REACTIVITY CONTROL SYSTEMS

CEA DROP TIME

DESCRIPTION OF AMENDMENT REQUEST

FIGURE 1
UNCONTROLLED CEA WITHDRAWAL (LOW POWER)

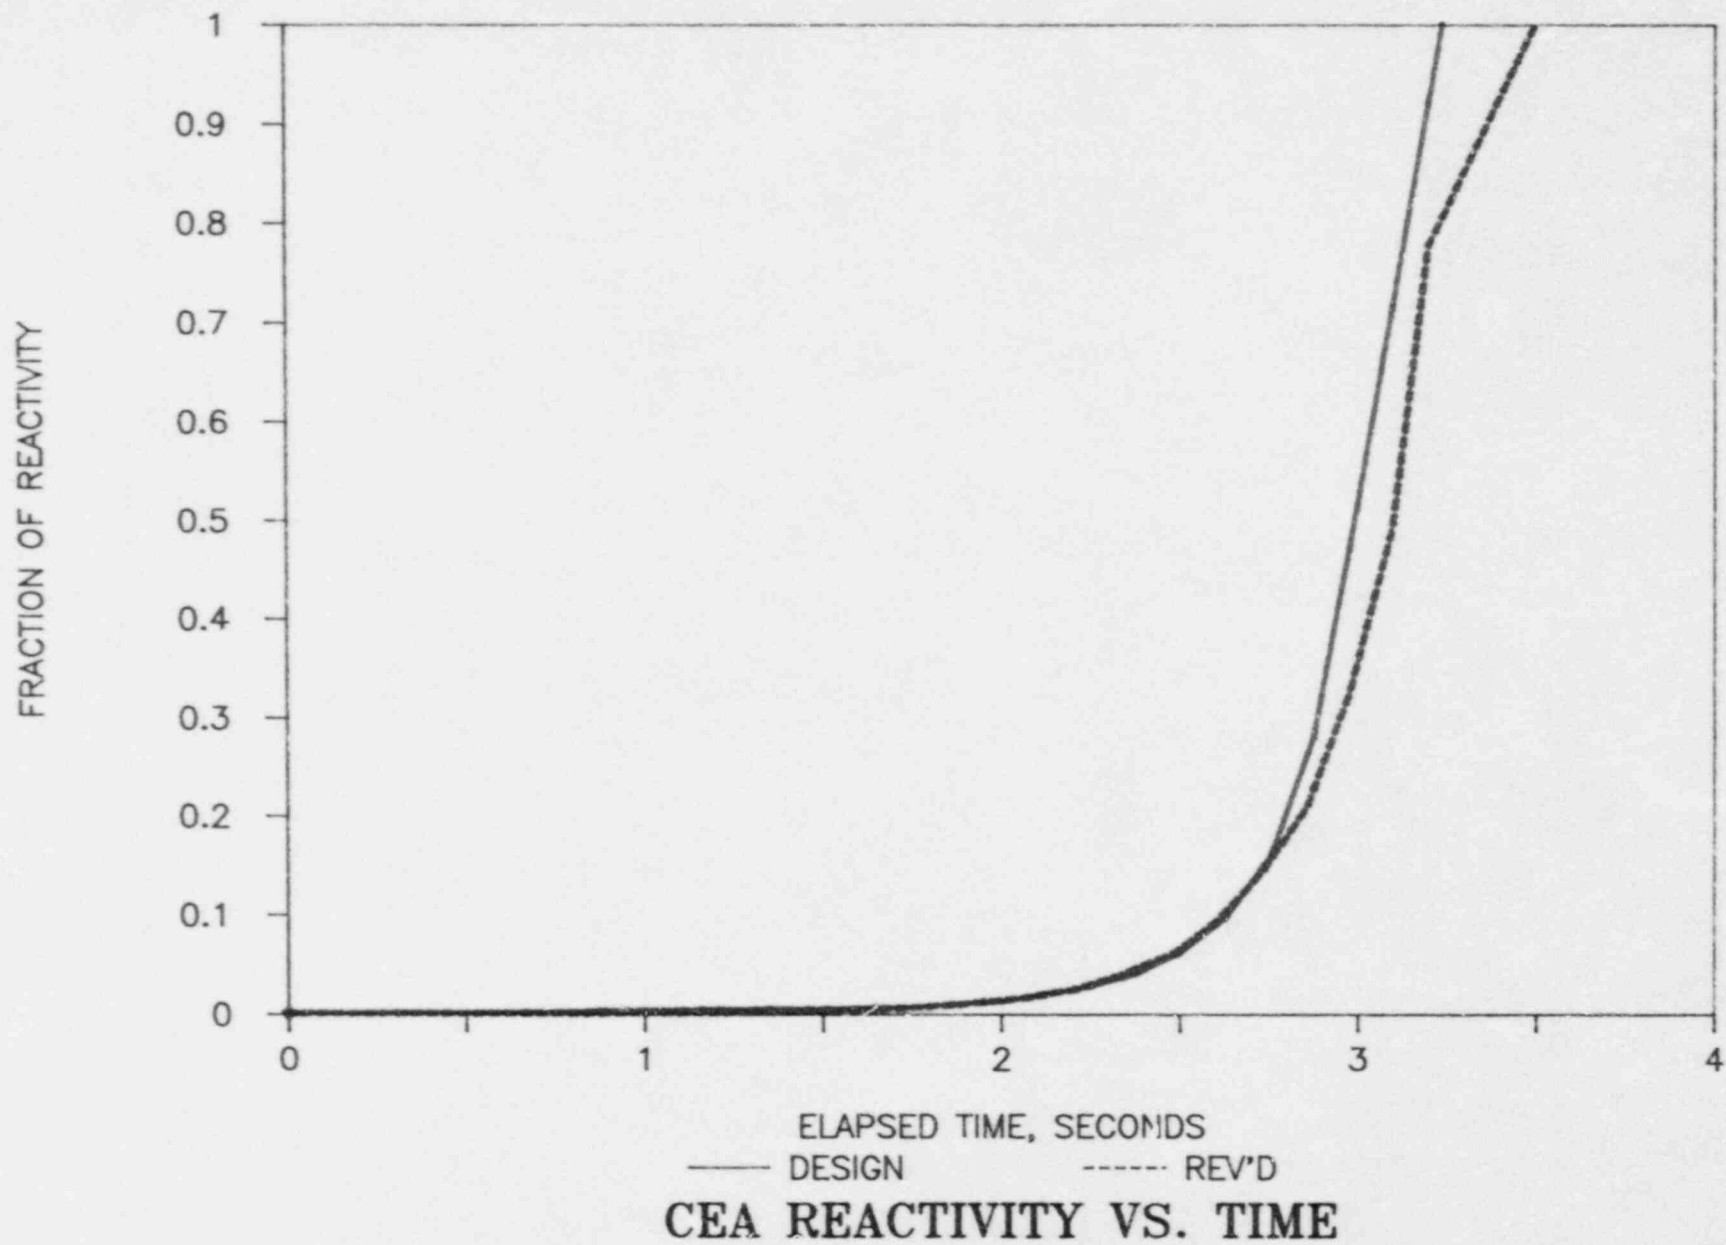
This event approaches a SAFDL (minimum DNBR) at approximately 2.2 seconds after the trip breakers open (Table 7.1.6-2 of ANO-2 Cycle 2 Reload Analysis Report (RAR)) As shown in Table 1, and illustrated in Figure 1, the revised scram reactivity data for a total scram insertion of 5.0 % $\Delta\rho$ and a +0.6 ASI (Table 7.1.6-1 of the Cycle 2 RAR) at the time of approach to a SAFDL, is more conservative than the design data. Therefore, the conclusions of this event are unchanged. This event was previously evaluated for the effects of increased CEA drop times (using CEA drop times of 3.18 seconds) by AP&L letter 2CAN058801 dated May 5, 1988.

This event approaches a SAFDL (minimum DNBR) at approximately 2.2 seconds after the trip breakers open (Table 7.1.6-4 of Cycle 2 RAR). As shown in Table 1, and illustrated in Figure 1, the revised scram reactivity data for a total scram insertion of 5.0 % $\Delta\rho$ and a +0.6 ASI (Table 7.1.6-3 of Cycle 2 RAR), at the time of approach to a SAFDL is more conservative than the design data. Therefore, the conclusions of this event are unchanged. This event was previously evaluated for the effects of increased CEA drop time (using CEA drop times of 3.18 seconds) by AP&L letter 2CAN058801 dated May 5, 1988.

The time of maximum deposited energy is at approximately 2.5 seconds after the trip breakers open (Figure 7.2.1-2 of Cycle 2 RAR). As shown in Table 1, and illustrated in Figure 1, the revised scram reactivity data for a total scram insertion of $2.4\% \Delta\rho$ and a $+0.6$ ASI (Table 7.2.1-1 of Cycle 2 RAR), at the time of interest, is more conservative than the design data. Therefore, the conclusions of this event are unchanged.

FIGURE 2
UNCONTROLLED CEA WITHDRAWAL - 100% POWER

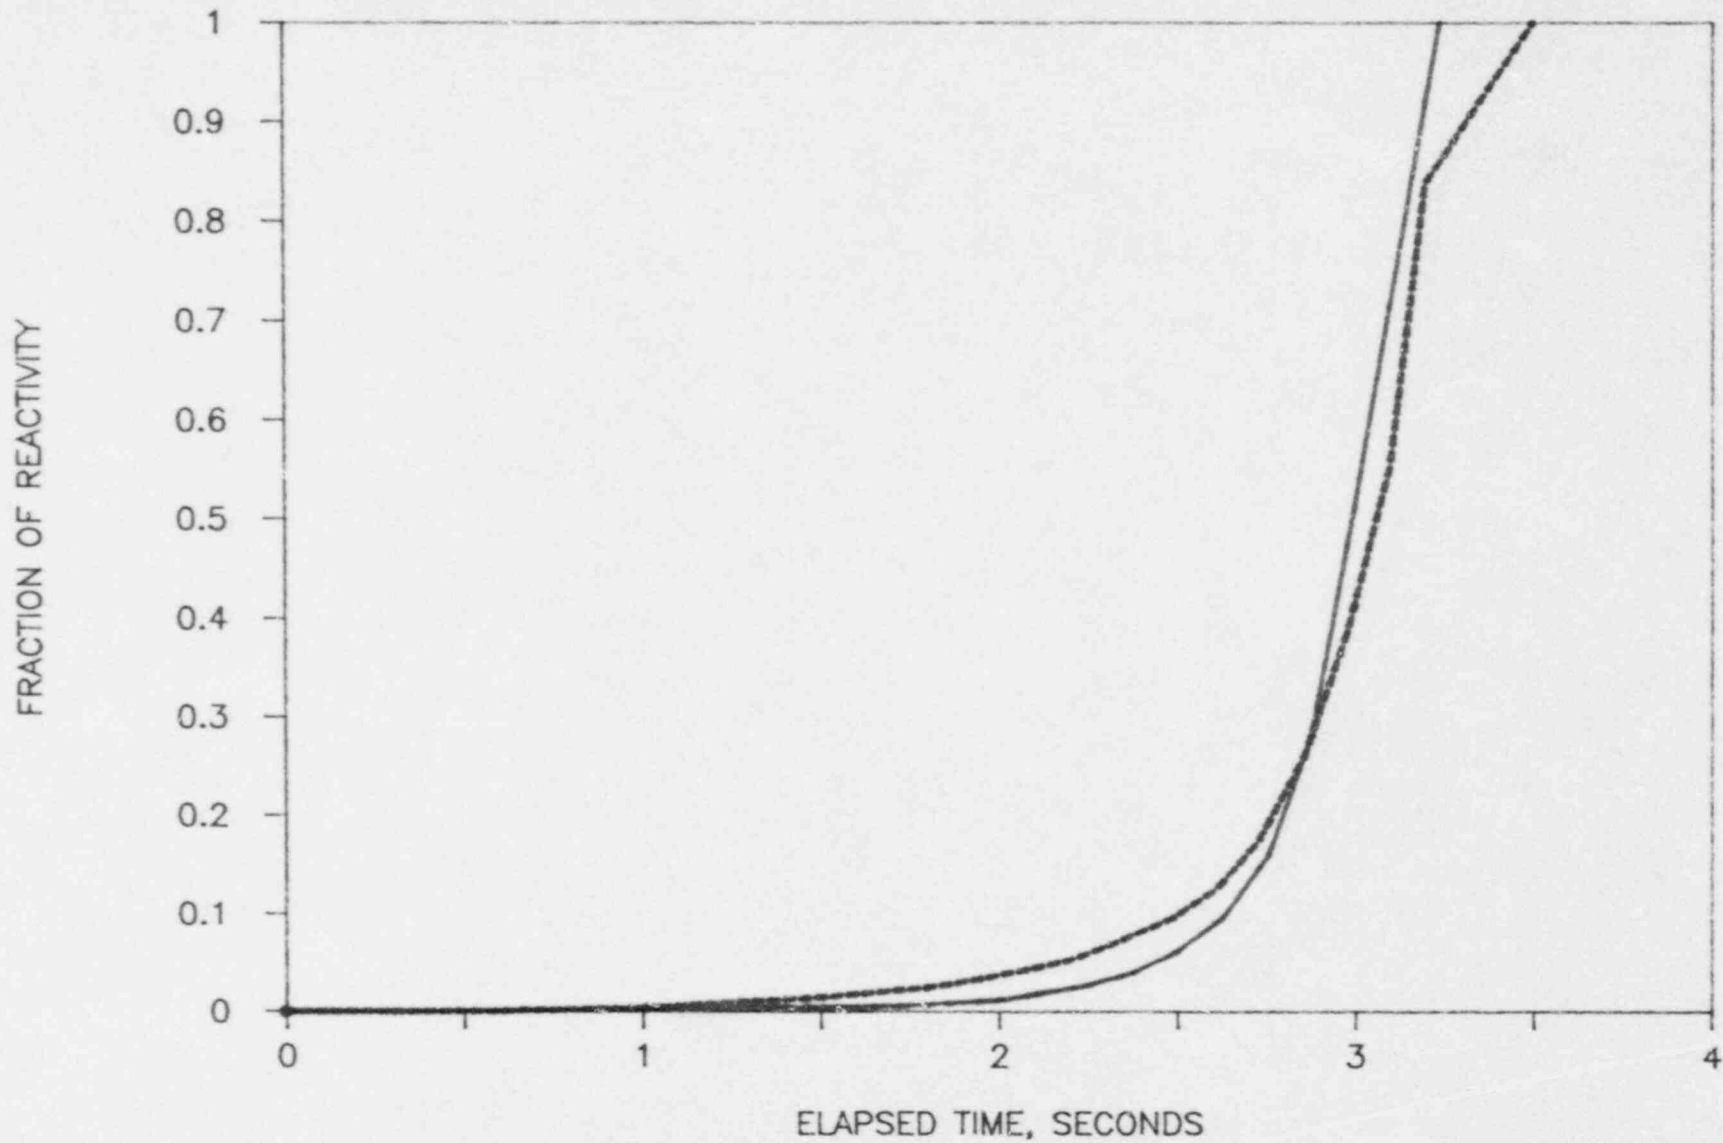
This event approaches a SAFDL (minimum DNBR) at approximately 0.9 seconds after the trip breakers open, (Table 7.1.6-6 of Cycle 2 RAR). As shown in Table 2 and illustrated in Figure 2, the revised scram reactivity data, which incorporates the increase CEA drop time of 3.2 seconds and the space-time neutronic adjustment, for a total scram insertion of 5.4 % $\Delta\rho$ and a +0.3 ASI, (Table 7.1.6-5 of Cycle 2 RAR), at the time of approach to a SAFDL is less conservative than the design data.

If the time of CEA insertion were delayed by 0.3 seconds (i.e., no credit for space-time neutronic adjustments) the maximum increase in the core average heat flux would be less than 0.4% relative to the value in Table 7.1.6-6 of Cycle 2 RAR. Therefore, the CPC DNBR power uncertainty multiplier (BERR1), a CPC addressable constant, will be conservatively increased by a factor of 1.005 in accordance with Technical Specification 6.8.1.g. This will ensure that a CPC DNBR trip

will occur at least 0.3 seconds earlier than the trip time presented in Cycle 2 RAR. This is more than sufficient to offset the effect of the increased holding coil decay time so that the conclusions of the event remain unchanged.

FIGURE 3
LOSS OF FLOW - FOUR PUMP COASTDOWN (-.03 ASI)

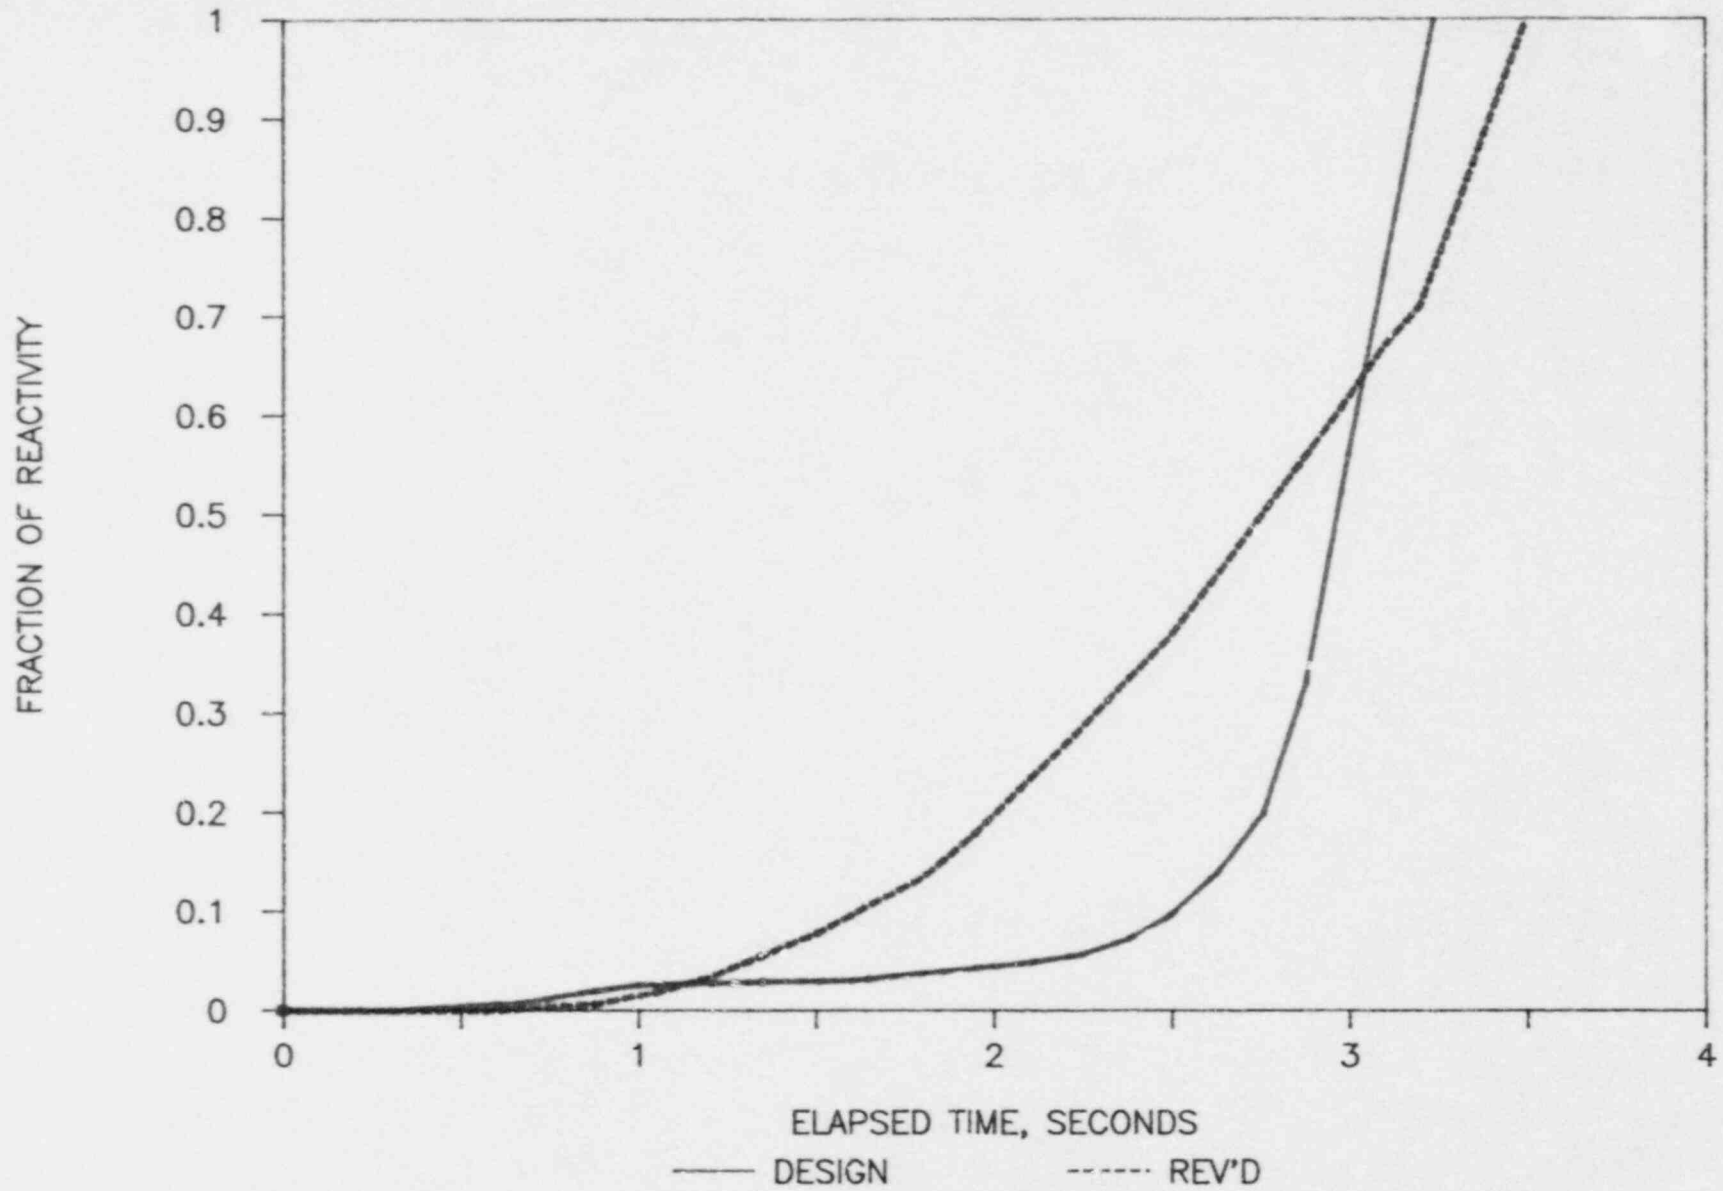
This event is initiated from the simultaneous loss of power to all four reactor coolant pumps resulting in the coastdown of the forced reactor coolant flow. This event approaches a SAFDL (minimum DNBR) at approximately 2.15 seconds after the trip breakers open (Table 7.1.8-2 of Cycle 2 RAR). The results of this transient, COLSS required overpower margin, are handled parametrically on Axial Shape Index (ASI) from within the Technical Specification limiting condition for operation (LCO) of +0.3 to -0.3 ASI. As shown in Tables 3 through 5, and illustrated in Figures 3 through 5, the revised scram reactivity data at the time of approach to a SAFDL is more conservative than the design data. The data represents a total scram insertion of 8.0 % $\Delta\rho$ and the full range of the ASI LCO. Therefore, the conclusions of this event are unchanged.

FIGURE 6
LOSS OF FLOW - SEIZED ROTOR

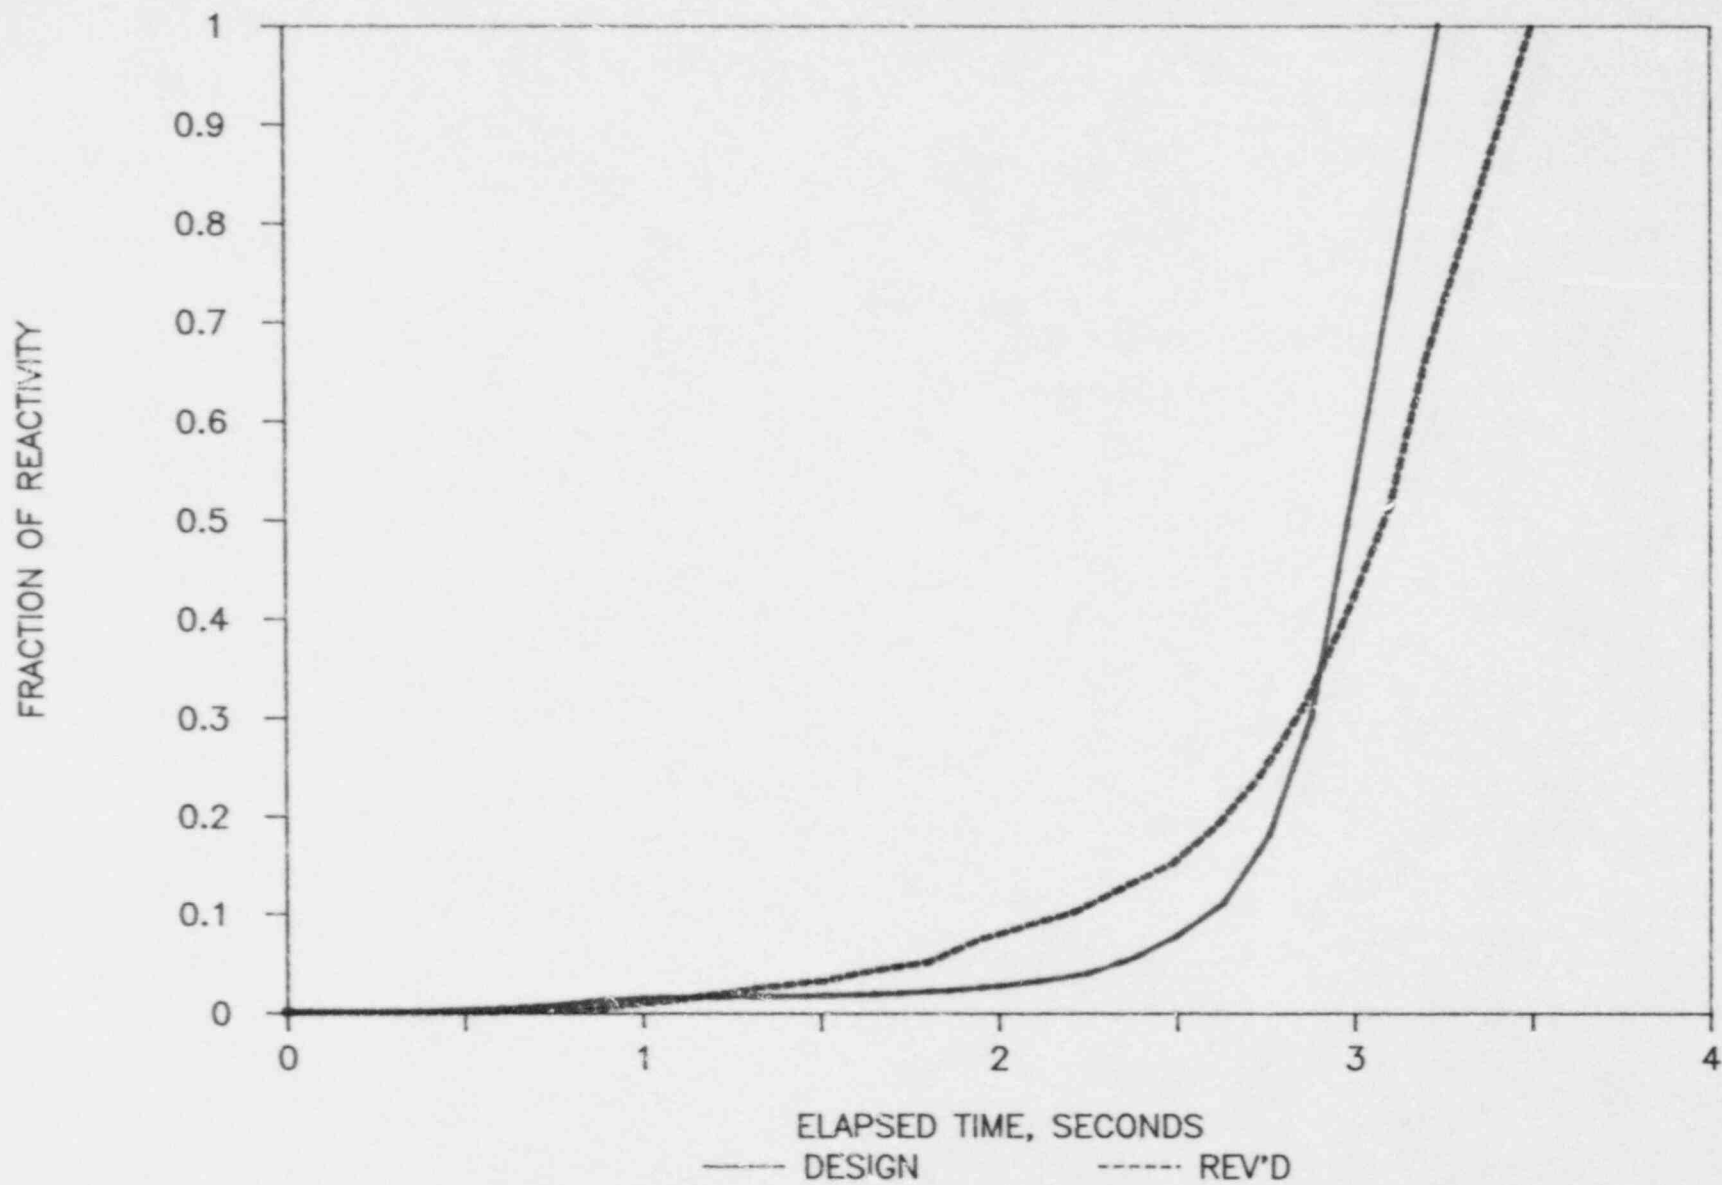
This event is initiated by the rapid stop (seizure) of one reactor coolant pump rotor and results in the rapid coastdown of core flow to the asymptotic 3-pump flow rate. The currently approved analysis predicts that the event will exceed a SAFDL (minimum DNBR) and fail a small amount of fuel. The failed fuel calculation is done at asymptotic flow conditions and is therefore insensitive to a small delay in the CEA drop time. However, as shown in Table 6, and illustrated in Figure 6, the revised scram reactivity data for a total scram insertion of 8.0 % $\Delta\rho$ and a 0.0 ASI (Table 7.2.5-2 of Cycle 2 RAR), at the time of approach to a SAFDL is more conservative than the design data. Therefore, the conclusions of this event are unchanged.

FIGURE 7
FEEDWATER LINE BREAK

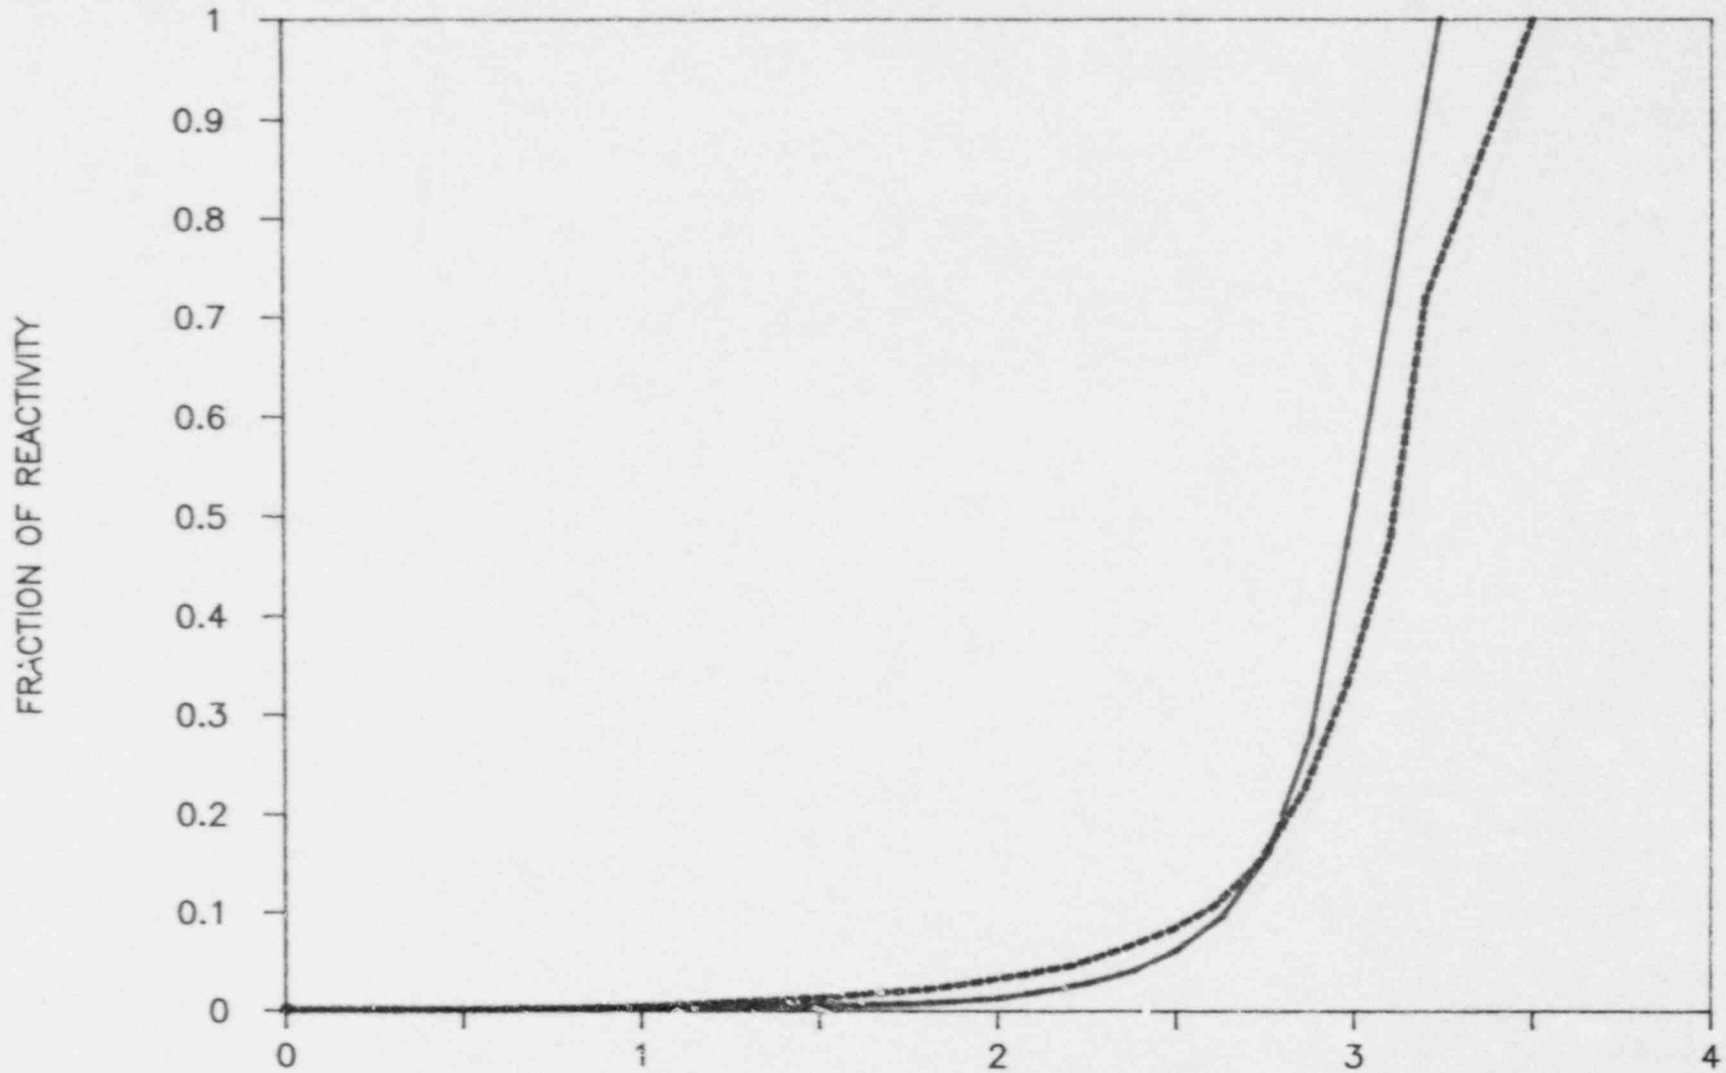
This event approaches the upset pressure limit (i.e. the RCS pressure safety limit). At approximately 2.7 seconds after the trip breakers open, the reactor power has decreased enough to terminate the event. The time of peak RCS pressure is 3.2 seconds after the trip breakers open. As shown in Table 7, and illustrated in Figure 7, the revised scram reactivity data for a total scram insertion of 7.0 $\% \Delta \rho$ and a +0.3 ASI (Table 7.2.3-1 of Cycle 2 RAR), at the time of interest is more conservative than the design data. Therefore, the conclusions of this event are unchanged.
